Application No: CH/21/0434

Location: 'Parcel I' - Land to the West of Pye Green, Land west of Pye Green Road, Cannock

Proposal: Approval of Reserved matters following outline approval (CH/19/421) Appearance, Landscape, Layout, Scale

Planning Control Committee

Drawing:
 Visibility Splays

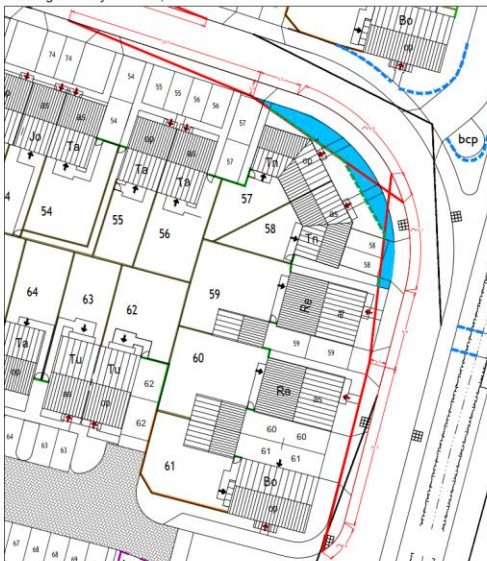
Visibility splays of 2.4m x 25m, in line with a design speed of 20mph, were requested for all internal junctions. Following amendments to the proposed boundary treatments, the Site Layout plan now indicates adequate visibility splays are achievable from all proposed internal junctions.
